## FIELD REVIEW REPORT/DEFICIENCY REPORT

DATE OF VISIT: December 5, 2018, January 29, 2019 REPORT NO. 02

OWNER: Malahat Nation PROJECT: Multipurpose Building

Photo 02: Multipurpose Building: Progress photo: Foundation and slab

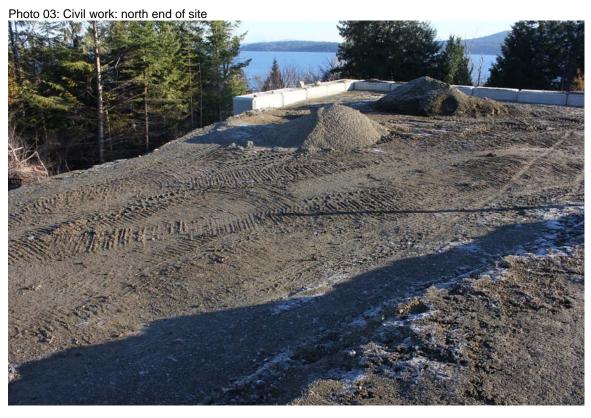
ITEM	PHOTO	COMPONENT	OBSERVATION	COMMENTS			
December59, 2018							
A1.1	01, 02	Progress photo	Foundation and slab in progress. Underground services installed				
A1.2	03	Civil work, north end of building	Additional fill required to provide adequate firefighting access around site	Civil engineer to issue additional information regarding fill and grading at north end of site
